Oxford Knit Composite Ltd.

19 August 2021

Observations

**A4: (TABLE-3): ALLOWABLE BEARING CAPACITY OF SHALLOW FOUNDATION
(F.S = 2.50)**

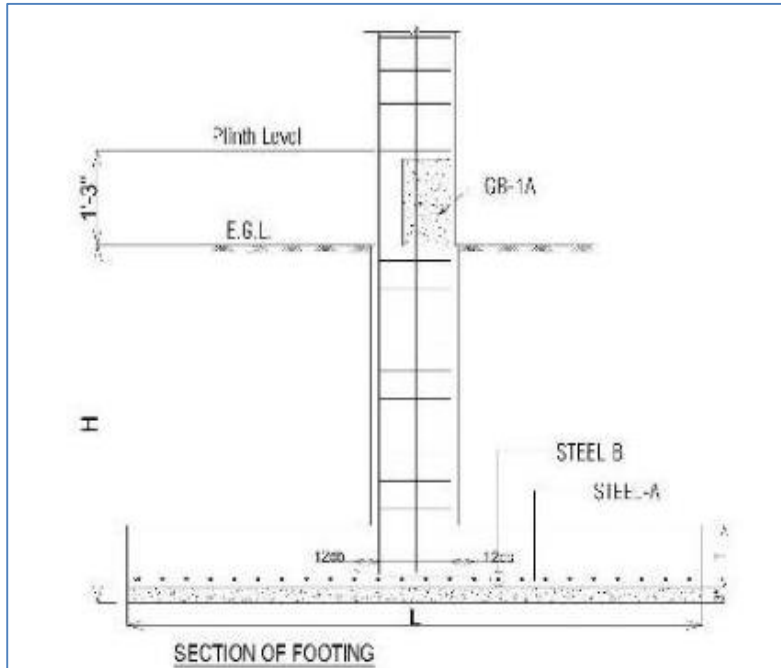
Footings are stressed above normal design limit

As per geotechnical investigation report, the allowable bearing capacity is 0.46 tsf (49.33 KN/m²) at depth 5 ft (1.5 m) considering F.S 2.5.

Cursory calculation indicates that footing appears to be stressed above normal design limits considering the recommended soil bearing capacity in geotechnical report and footing sizes in drawing. Factory engineer is required to review the adequacy of footings and comply with BNBC.

Vertical bracing plan

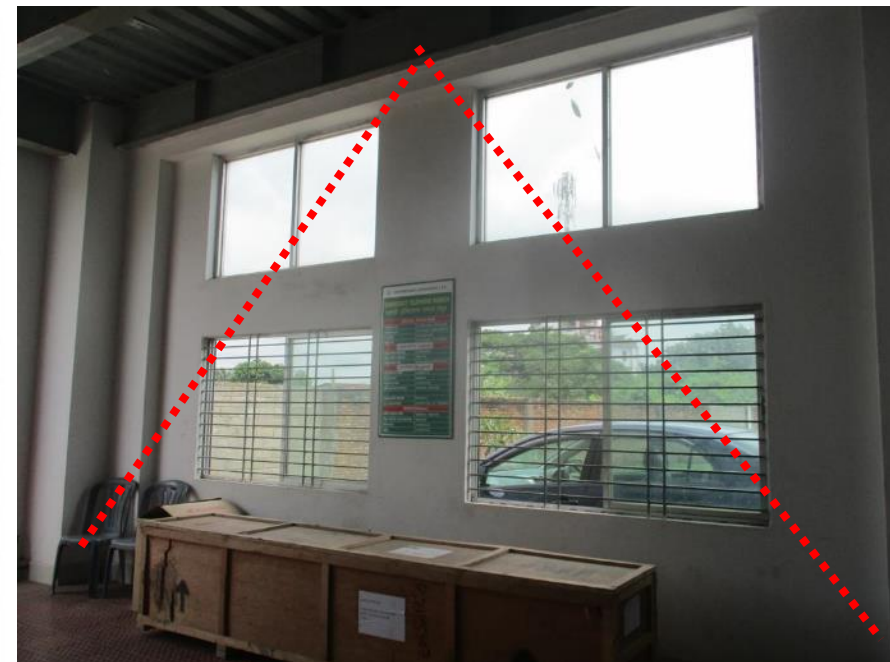
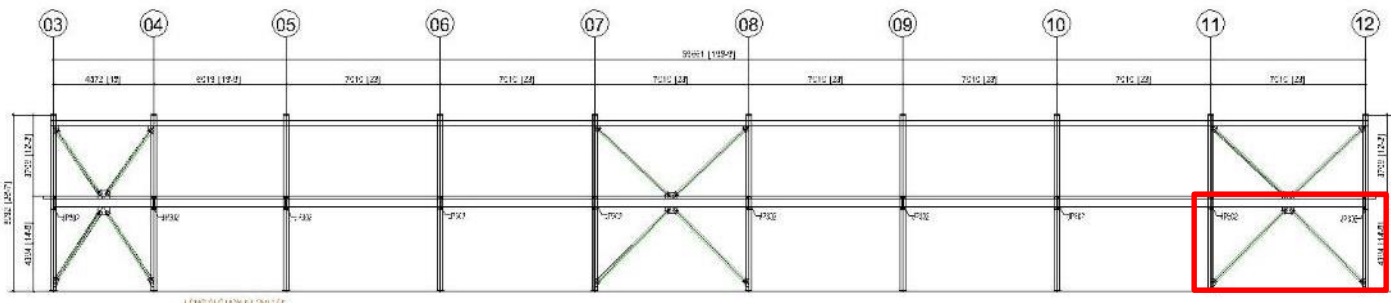
Vertical bracing missing in North-South direction

Missing bracing

Vertical bracing found missing in long direction.
Building engineer is required to re-install all the missing bracing as per the design specifications.

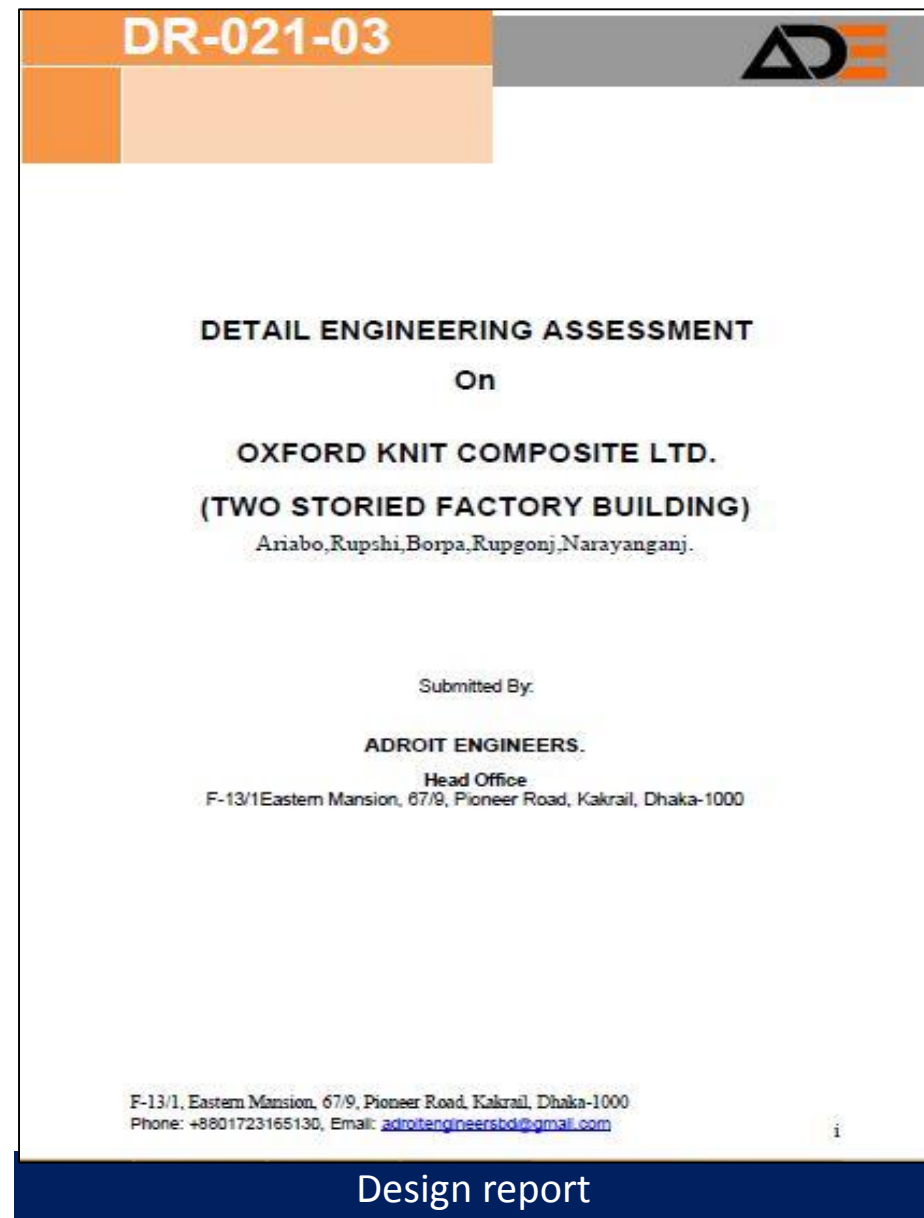
Serviceability checks not provided in design report

As per BNBC, every building or structure Designed shall have its design documents Prepared in accordance with the provision of Section 1.9.1 The design document shall include a design report, and a set of structural drawings, which shall be prepared in compliance with Section 1.9.1.1 and section 1.9.1.2 as per BNBC. The design report was available on site, but serviceability checks as per BNBC, and rafter adequacy checks are not addressed. Building engineer is required to prepare design report in compliance with section 1 9 1 1 (part 6 BNBC)

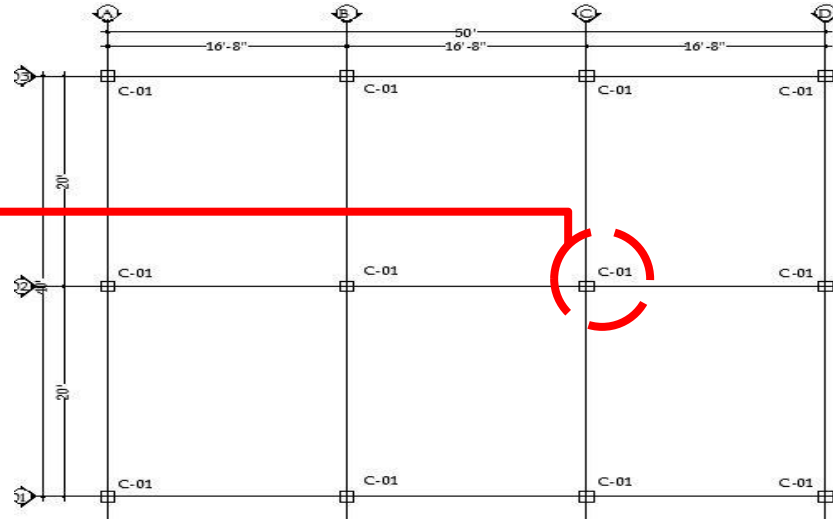
Corrosion on steel member

Corrosion in steel members was observed at toilet area. The extent of corrosion to be investigated by a qualified structural engineer.
